**Coal Combustion Residue Impoundment
Round 11 - Dam Assessment Report**

Colbert Fossil Plant
Tennessee Valley Authority
Tuscumbia, Alabama

Dewberry & Davis, LLC
Fairfax, Virginia

EP-09W001727
June 2012

Photo 16

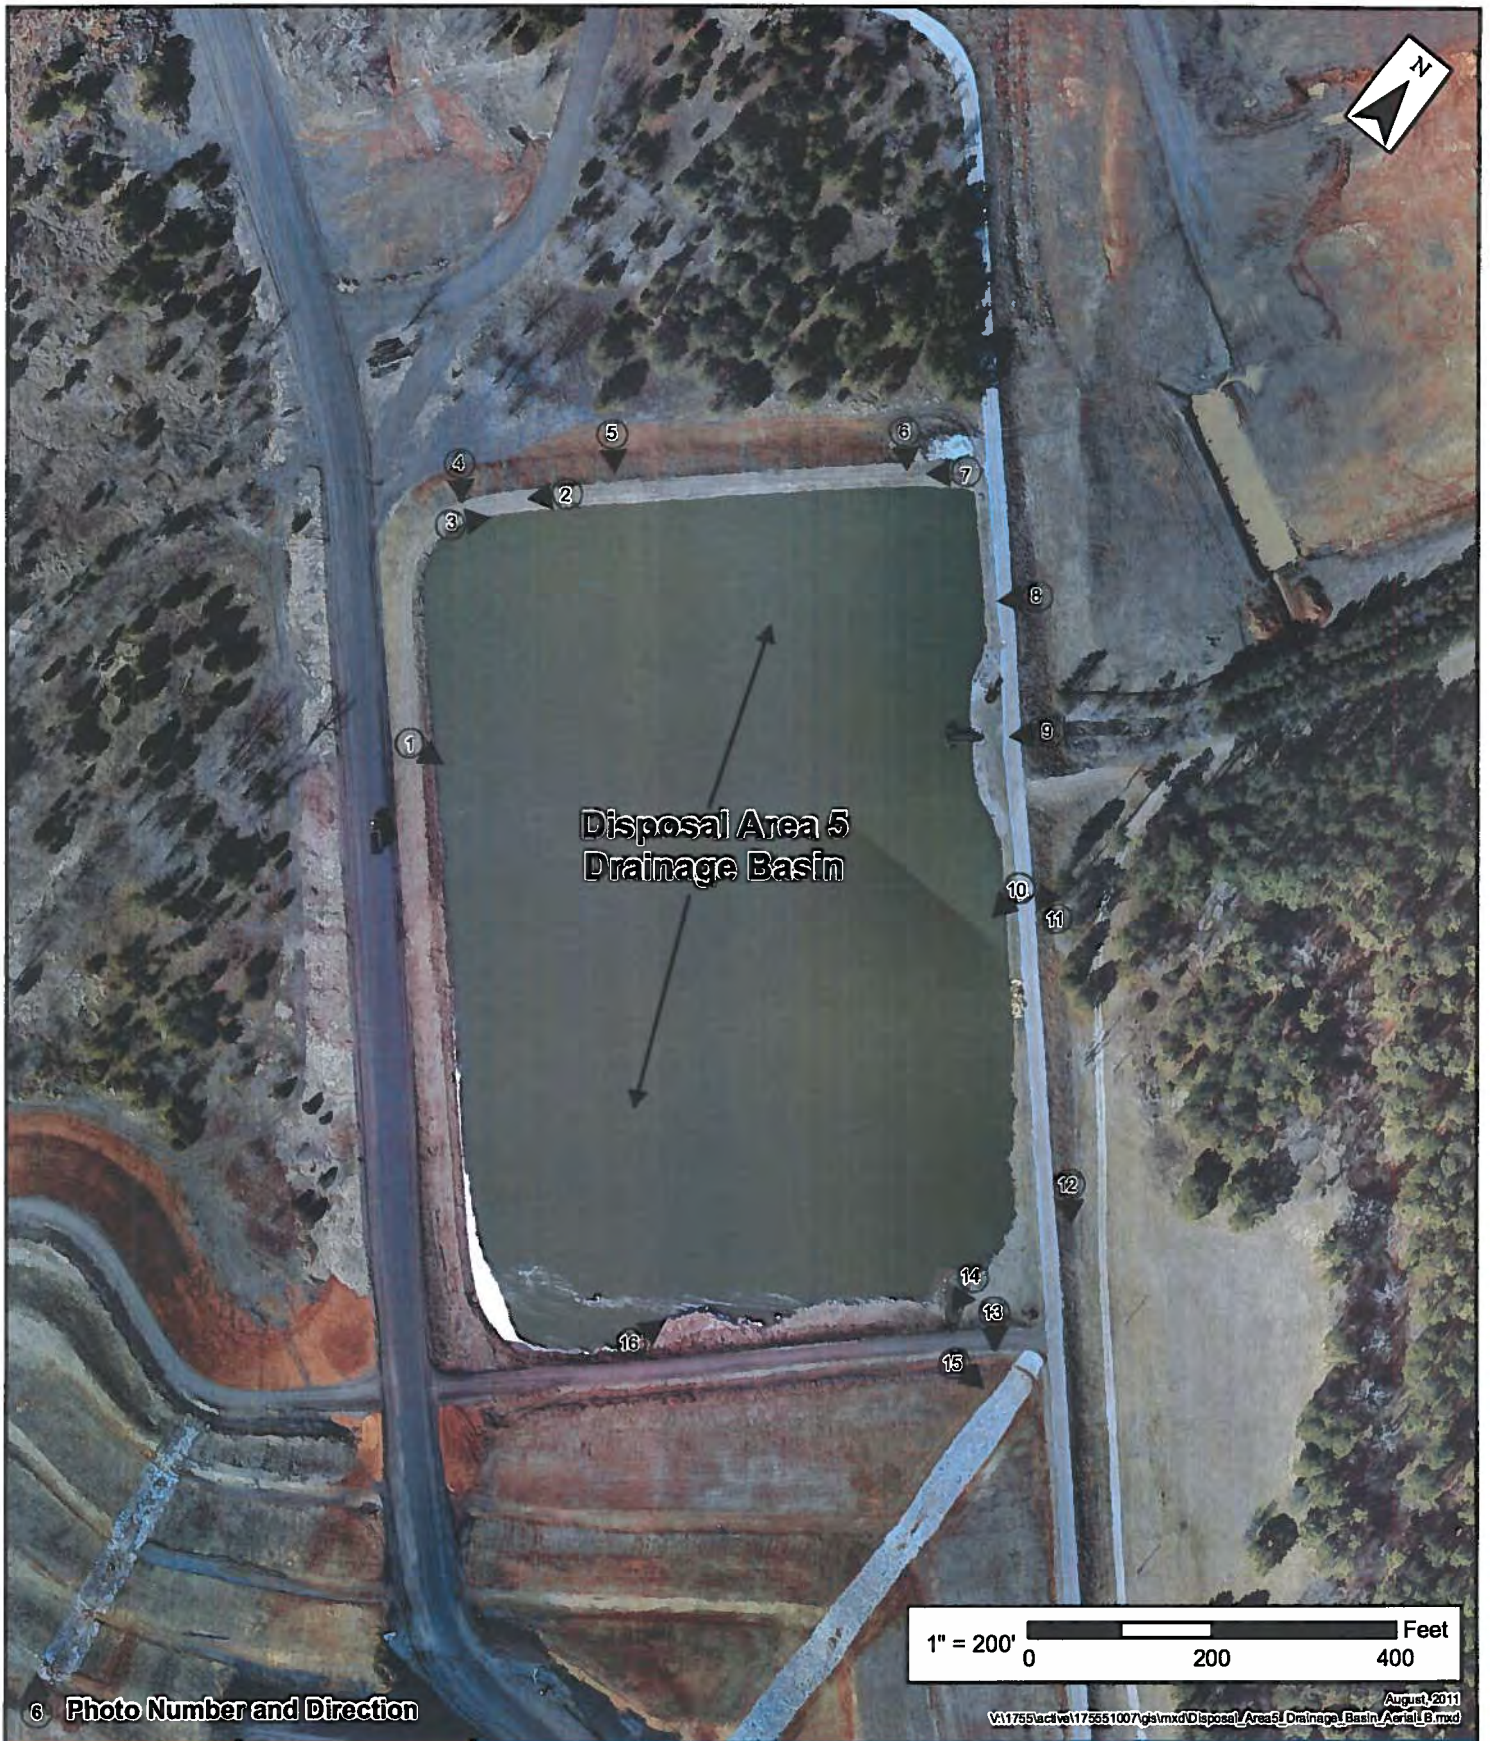
Overgrown area along interior of southeast dike.

Photo 6

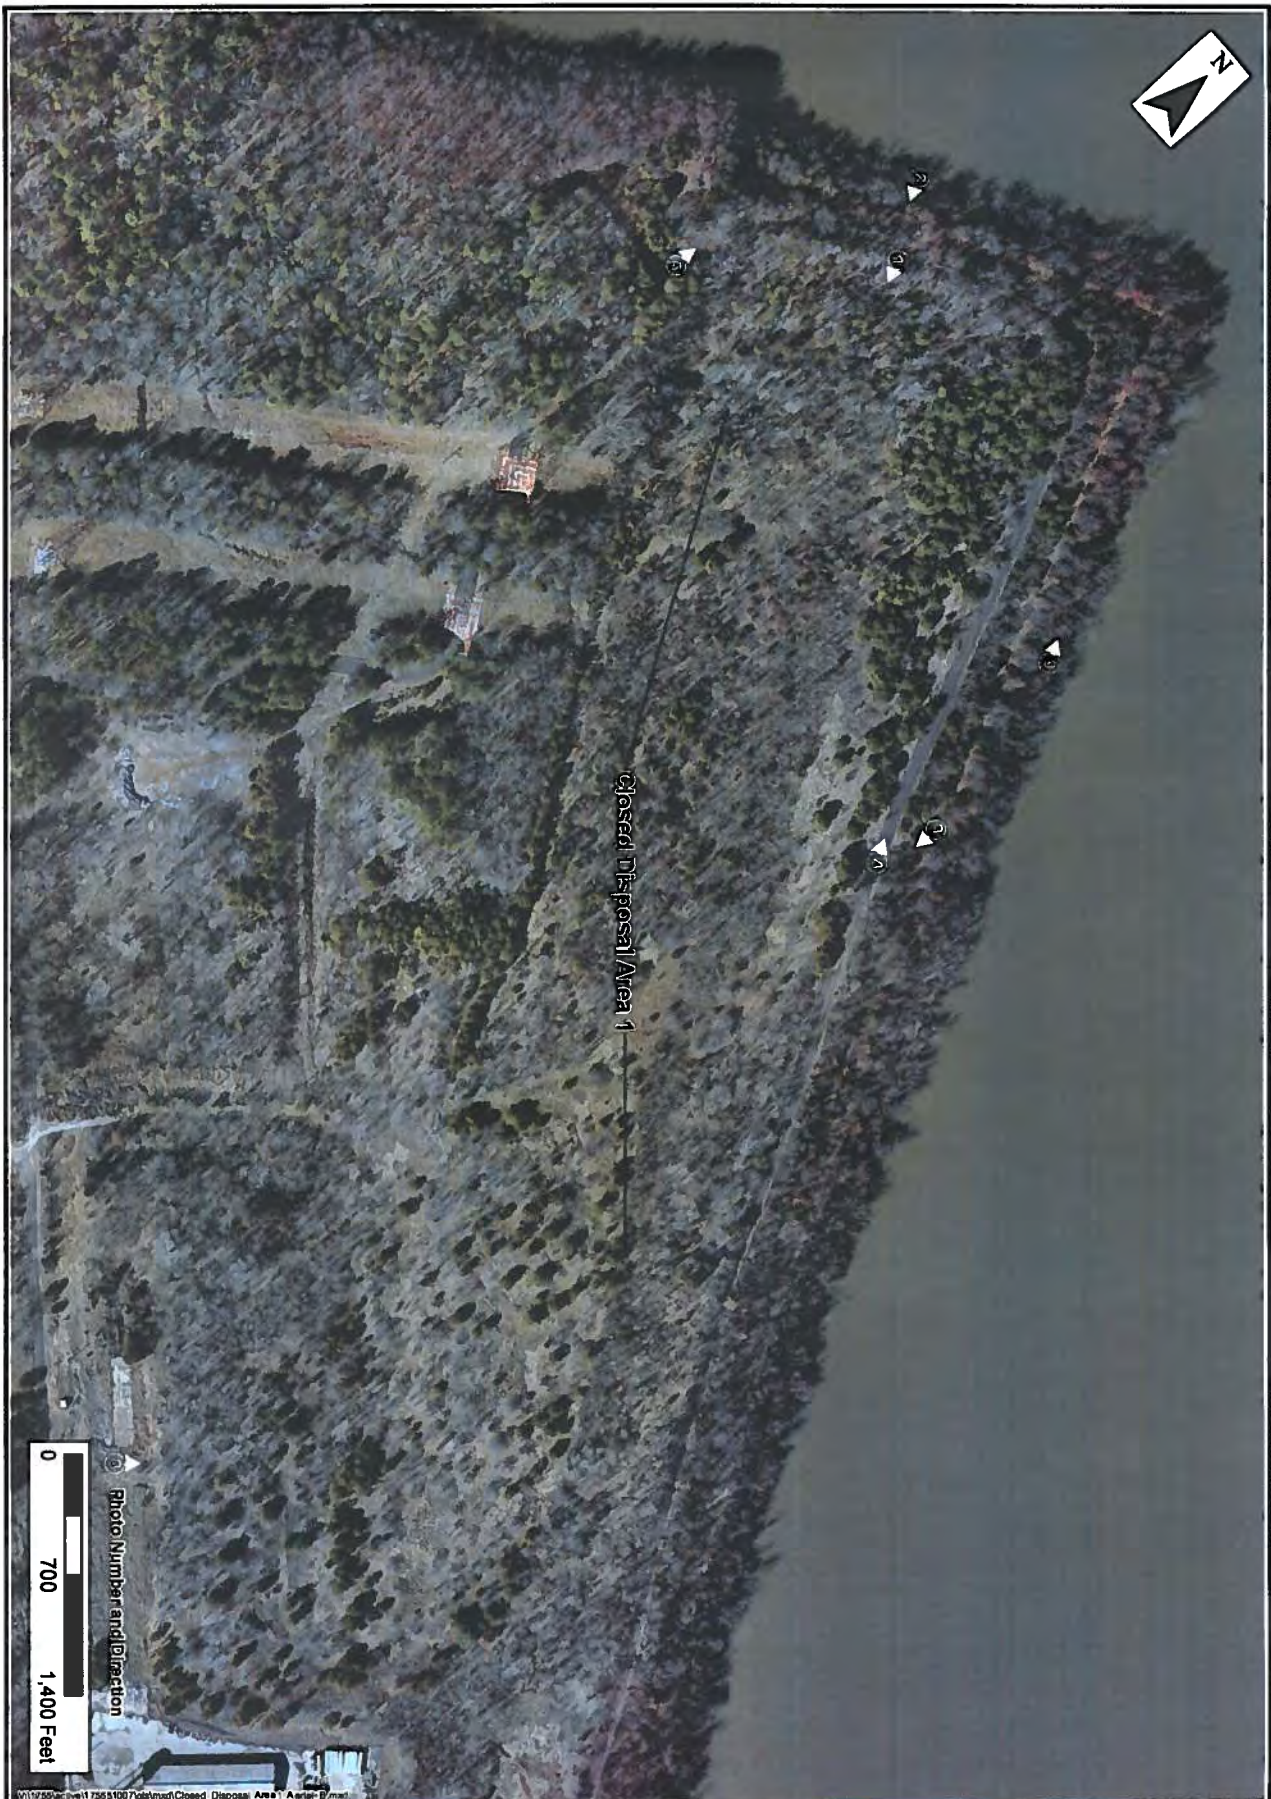
Typical view of boulders on exterior slopes.
